PUBLIC UTILITIES COMMISSION

RE: Sycamore- Peñasquitos 230-kV Transmission Line Project— Review of Minor Project Refinement #7 Request

**Sycamore to Peñasquitos
230kV Transmission Line Project
MPR 7 - 1A**

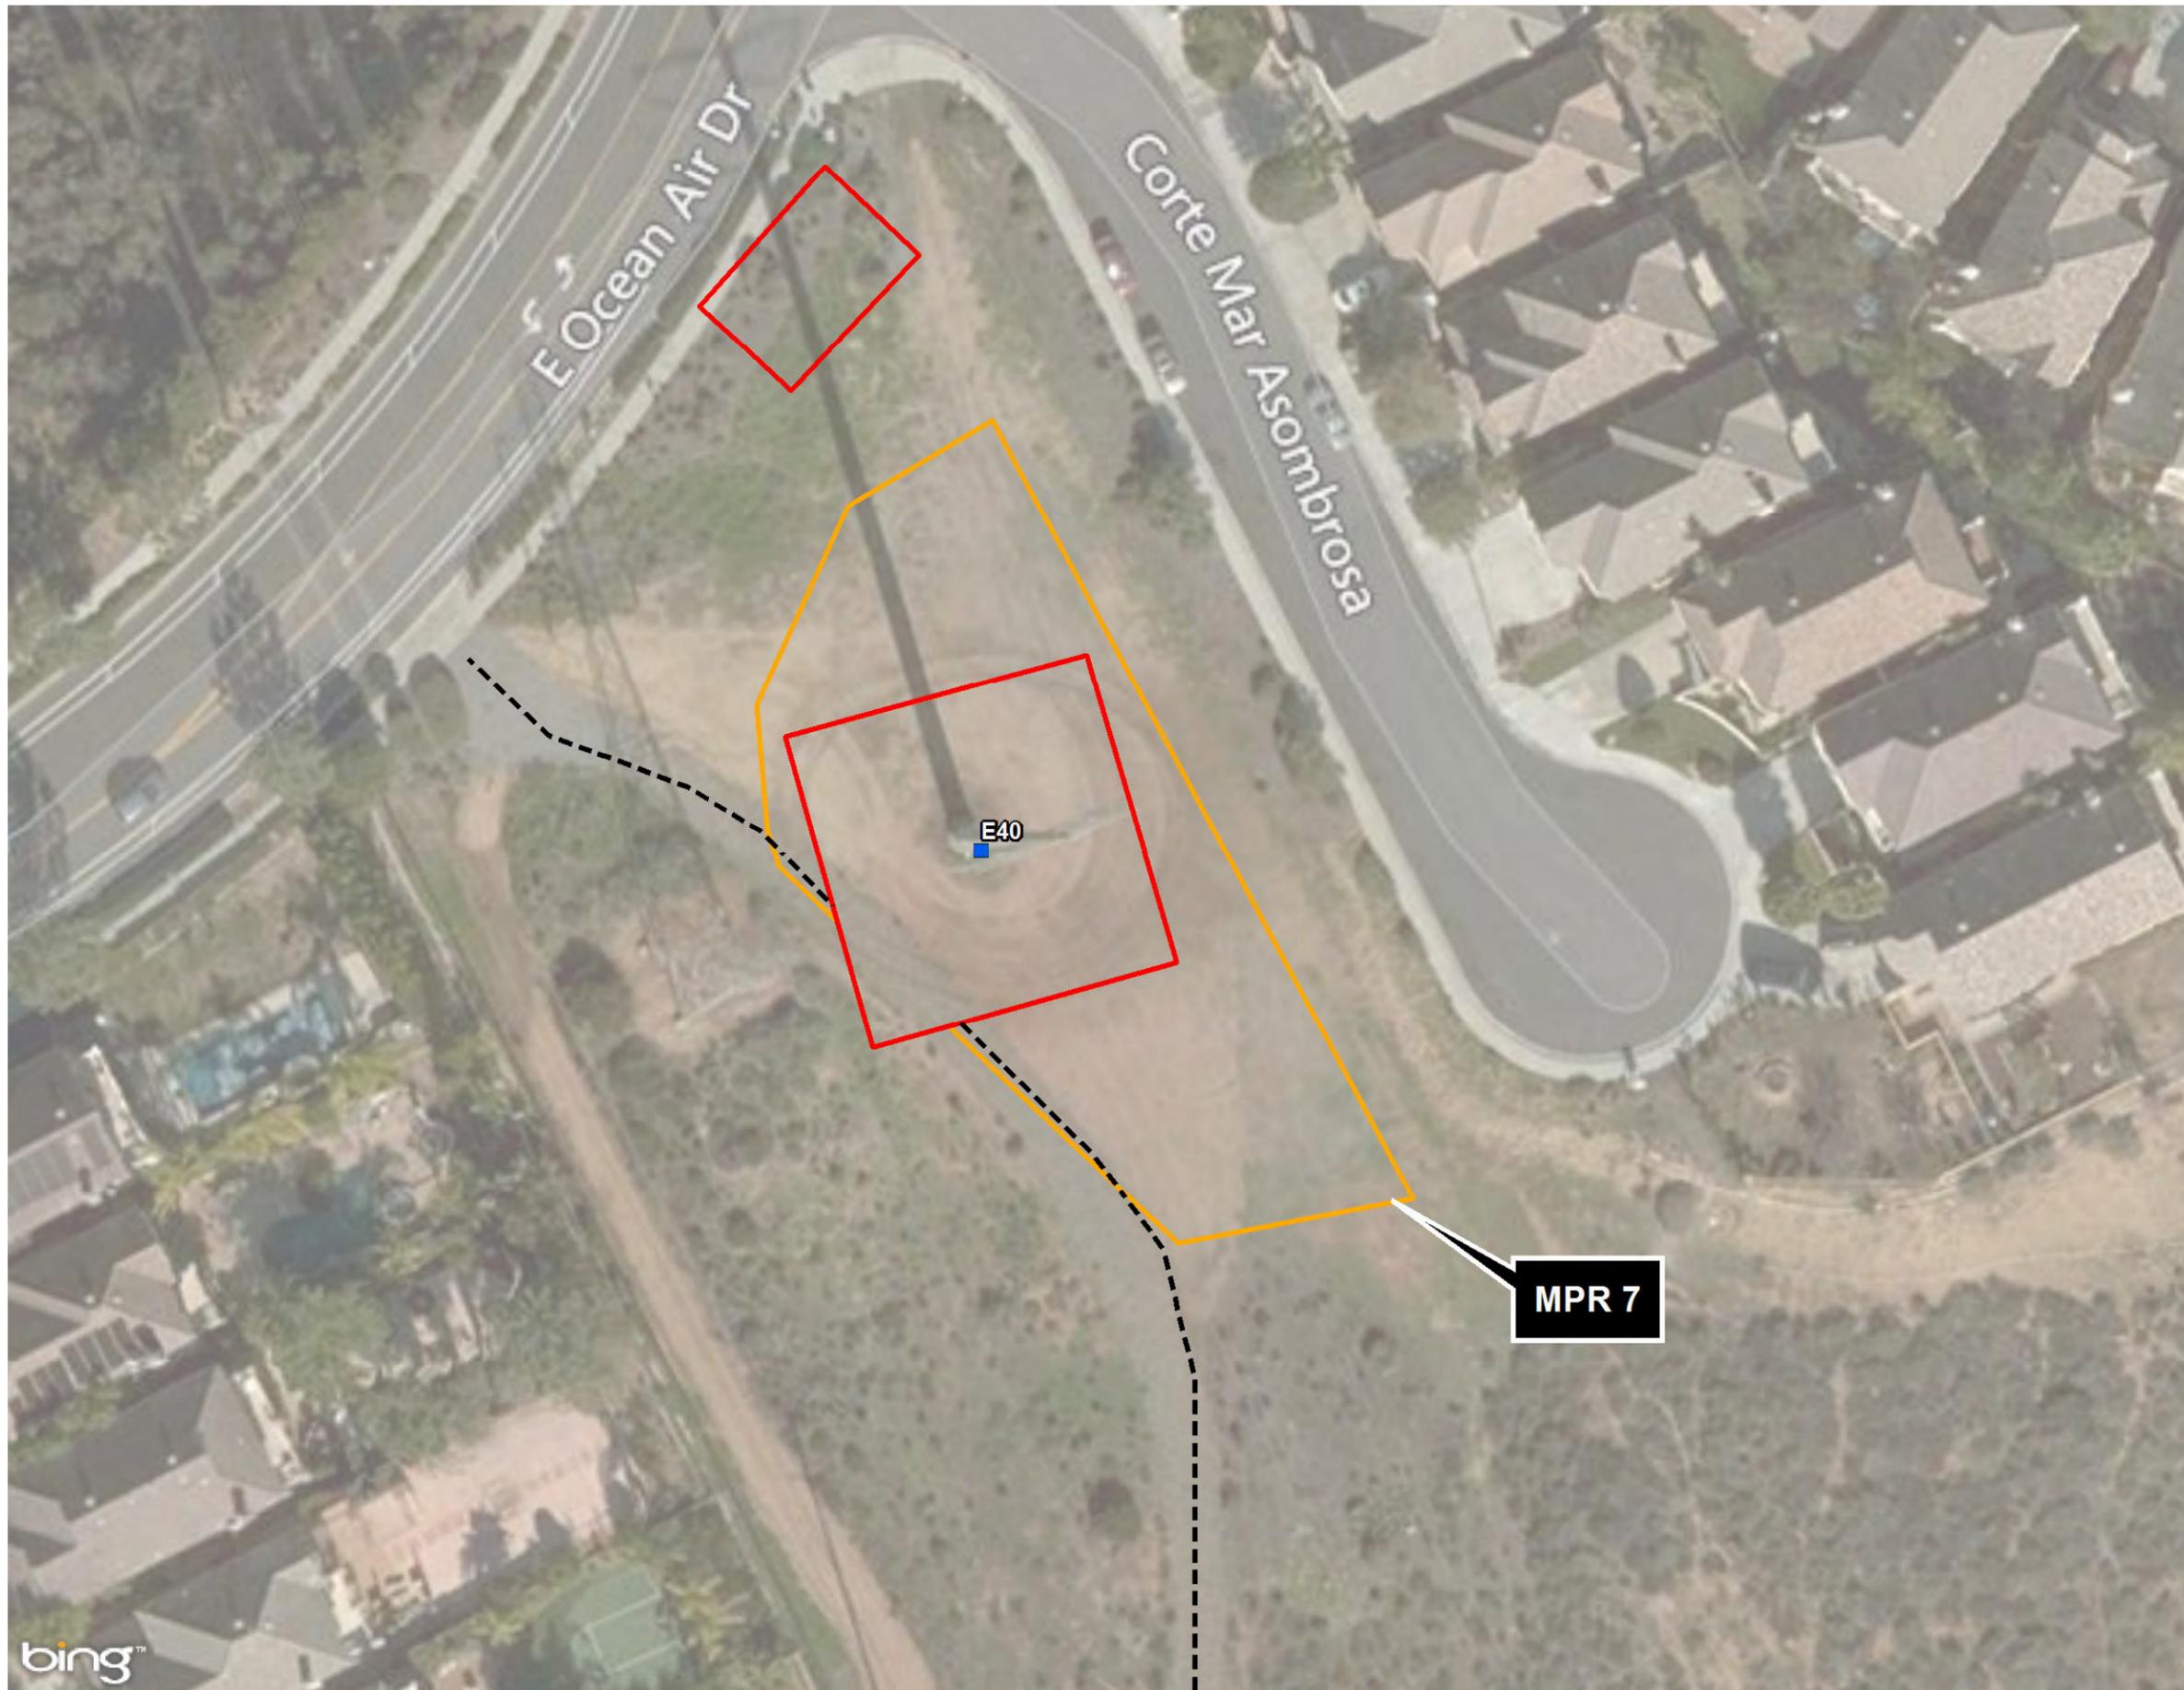
Under this proposed refinement, SDG&E seeks to extend the use of TEWS #1 through the end of the Project to allow for continued use of the staging area located at the intersection of Pomerado Road and Avenue of Nations.

The proposed refinement areas consist of disturbed ornamental habitat and compacted dirt at the staging area, and primarily bare ground at structure E40. Impacts are consistent with the impacts to biological resources identified in the FEIR, and will remain less than significant with mitigation.

**Sycamore to Peñasquitos
230kV Transmission Line Project
MPR 7 - 1B**

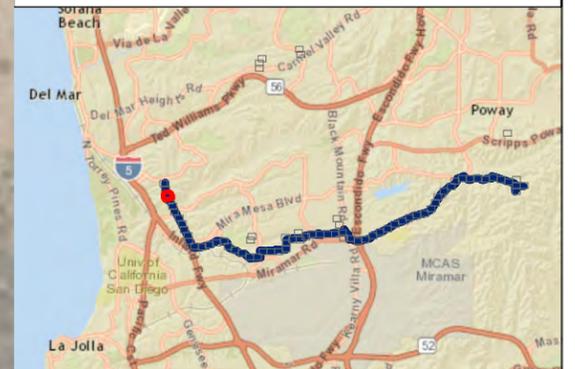
In addition, SDG&E seeks to extend the approved temporary work space surrounding structure E 40 as the approved temporary work space at this location is not large enough to adequately stage a crane and other construction equipment. The additional temporary work space also allows for safer construction equipment egress. Construction equipment (cranes and work trucks) would be staged in line with the existing overhead lines within the revised temporary work space area and would be used to hoist and install hardware on the existing tower.
